CITY OF SUNNYVALE REPORT
ZONING ADMINISTRATOR HEARING

February 13, 2013

File Number: 2012-7752 **Permit Type:** Use Permit/Variance/Design Review

Location: 379 Orchard Ave. (near Chestnut Ave.) (APN: 204-31-005)

Site
3/16" = 1'-0"

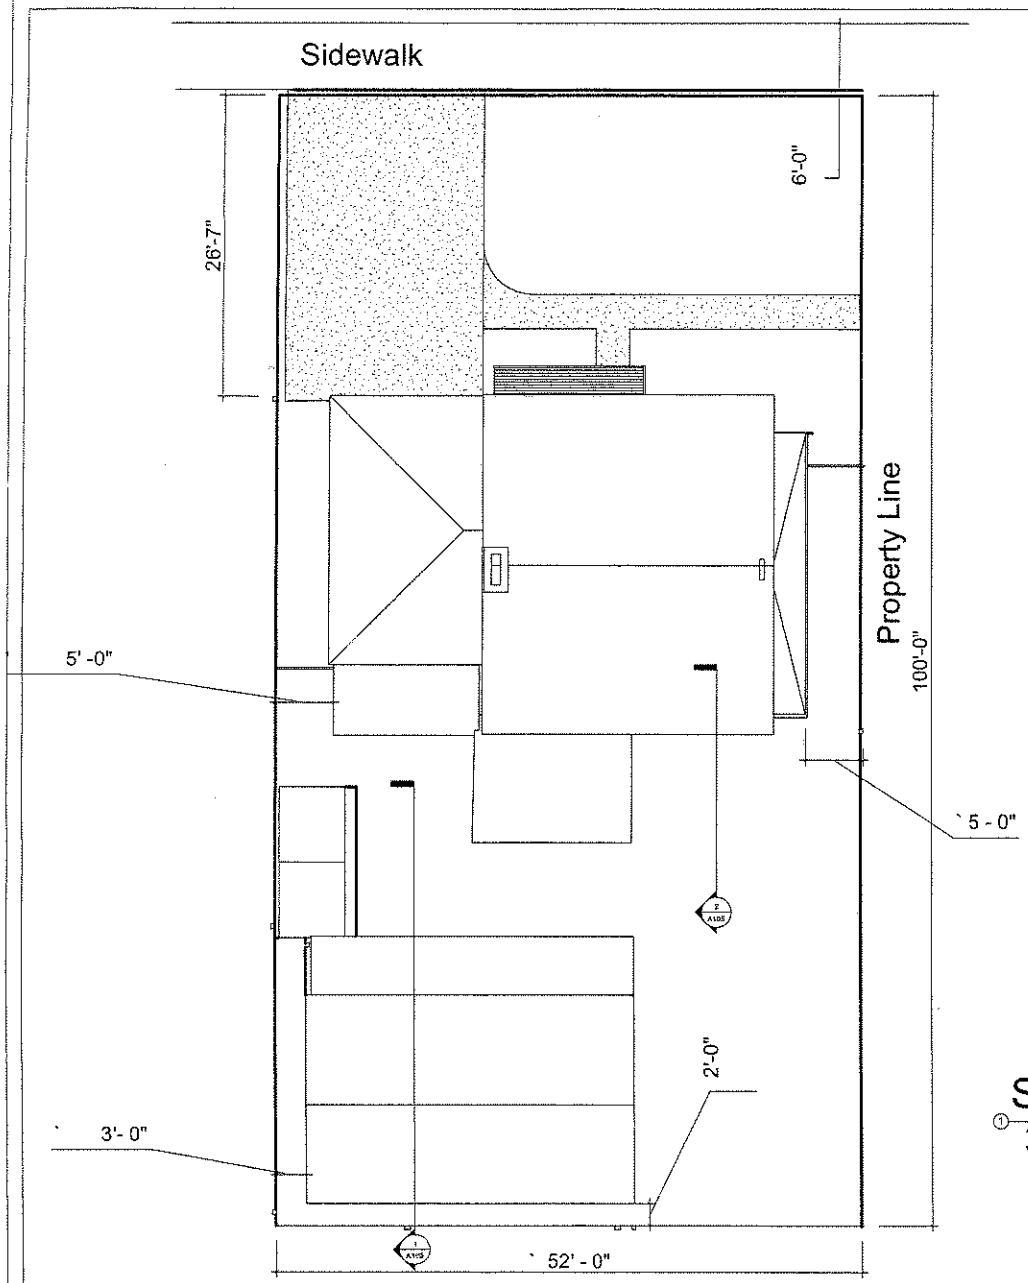
f) The 66 square foot utility building (storage shed) located at the rear of the home along the north property line shall be removed;

DEMO PLAN

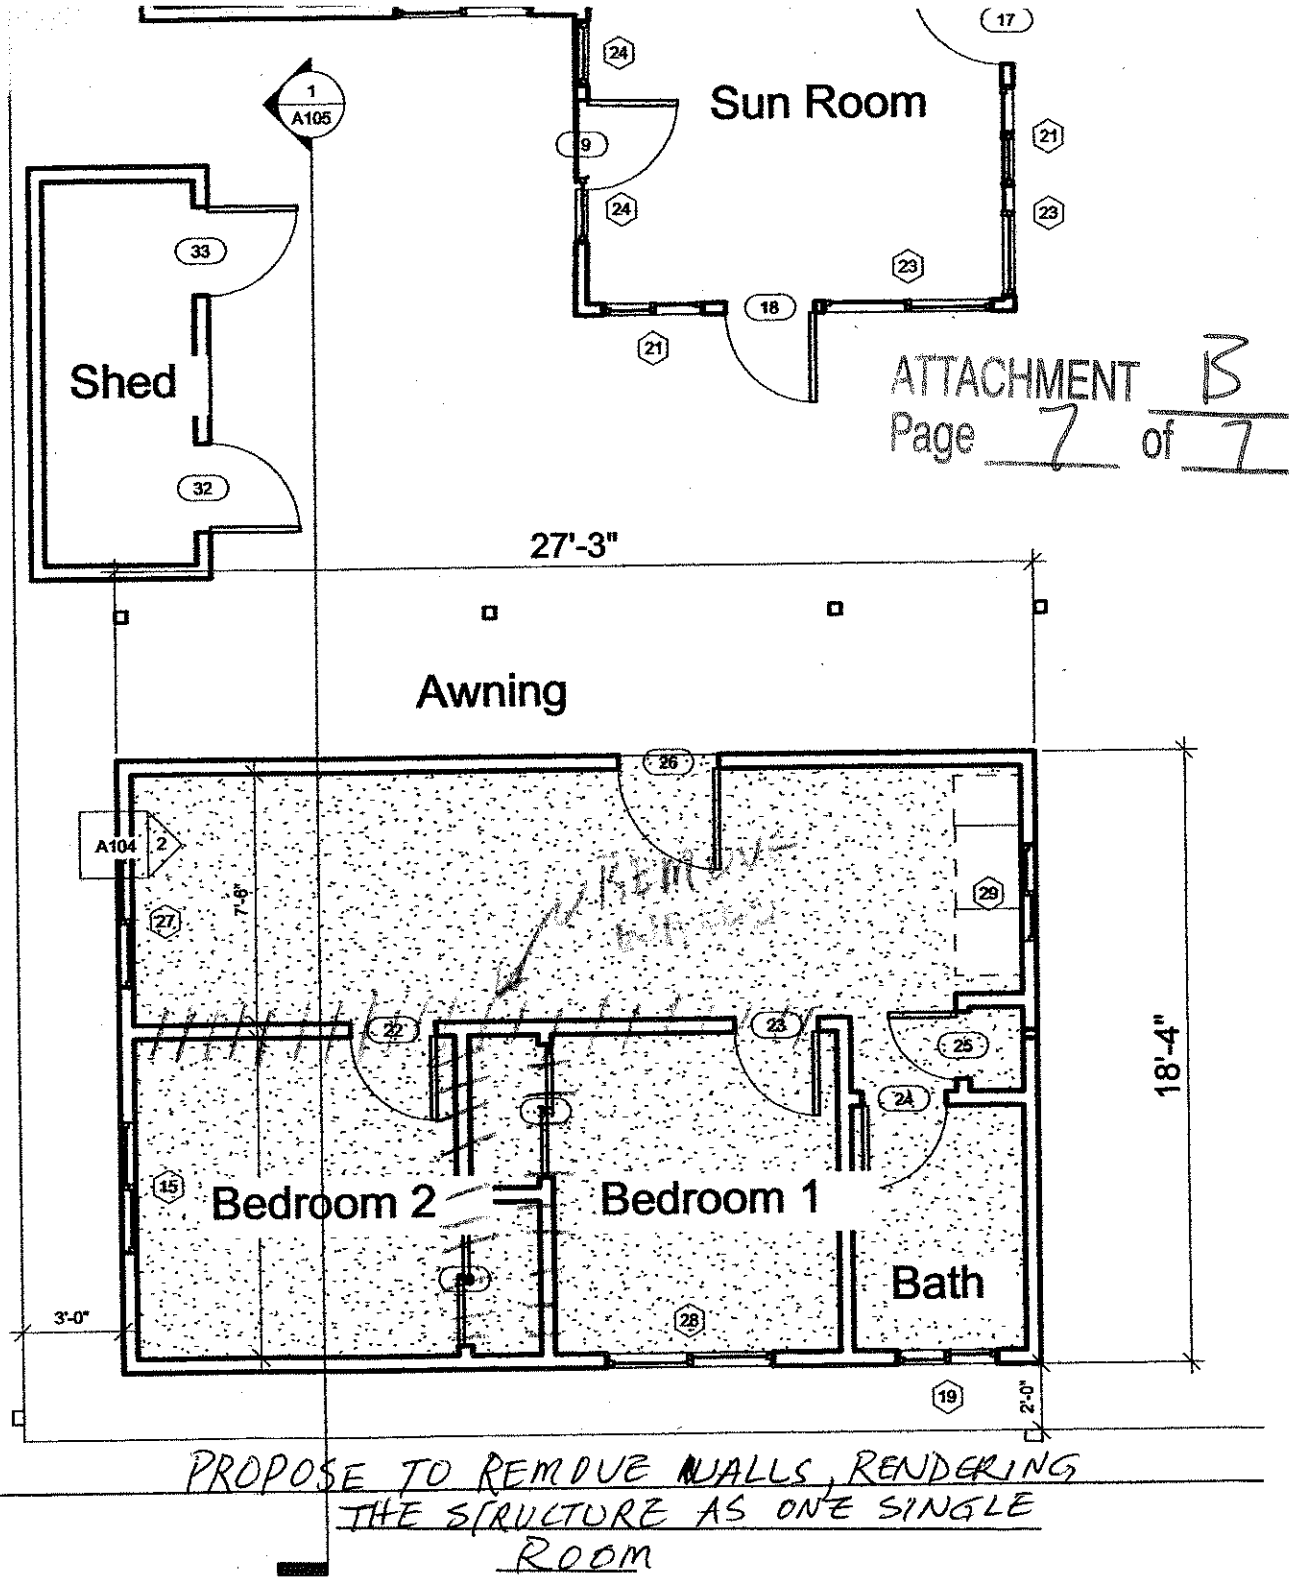
PROPOSE TO REMOVE WALLS, RENDERING THE STRUCTURE AS ONE SINGLE ROOM

Additionally, I am proposing to remove the wall dividing the structure so as to turn the structure into one big room. Please see attached sketch. With this modification to the structure, the additional covered parking requirement is not applicable.

e) The interior partition walls within the detached accessory structure creating multiple bedrooms and living areas shall be demolished resulting in only two areas: an open area and one bathroom;

SUNROOM SHOWING FACTORY PROVIDED WINDOWS AND PANELS

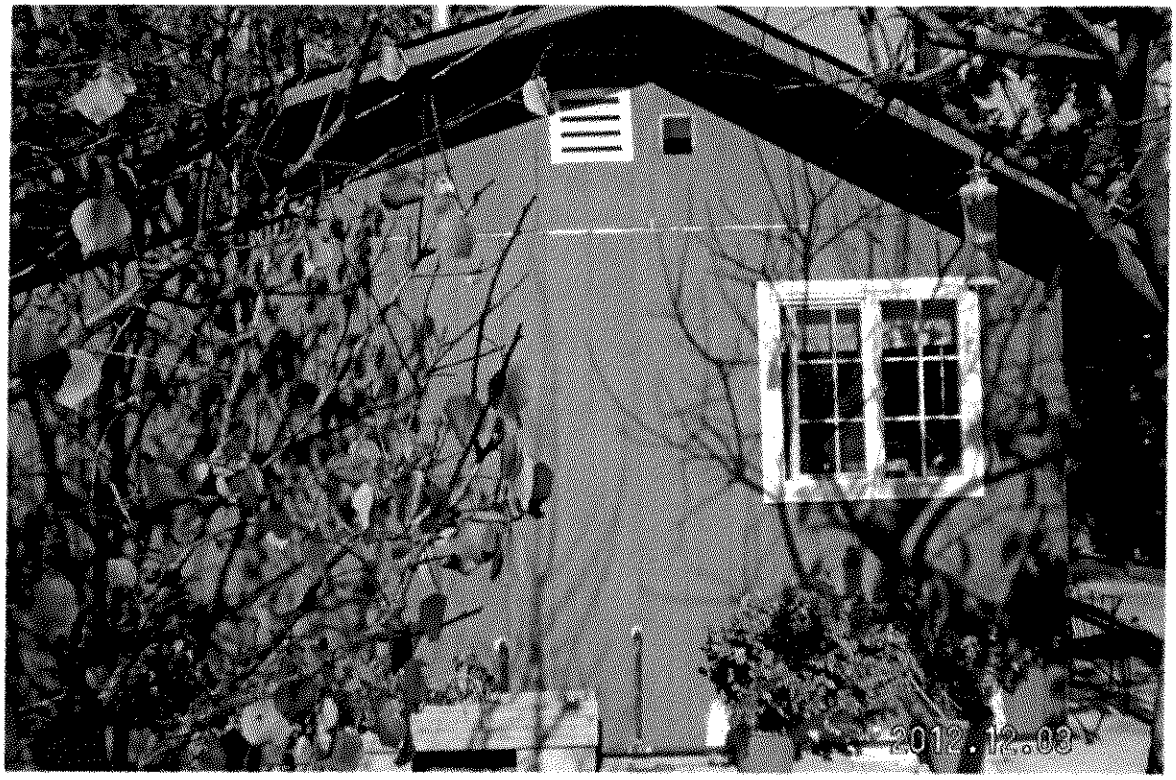
uses pre-fabricated panels consisting primarily of windows with the remaining panel area having a stucco appearance in a white color (Attachment C – Photographs). The sunroom has a flat metal roof. The area where the sunroom meets the main structure has been patched with stucco which is not painted. Pre-fabricated sunrooms have typically been permitted as rear additions for single-family homes, provided they present a high-quality finished appearance.

g) The area where the sunroom addition meets the main structure shall present an attractive and finished appearance. The patched stucco areas between the sunroom addition and the main structure shall be painted to match the sunroom or main structure. Any flashings, trims, window frames, or other details shall be integrated into the design and present a finished appearance.
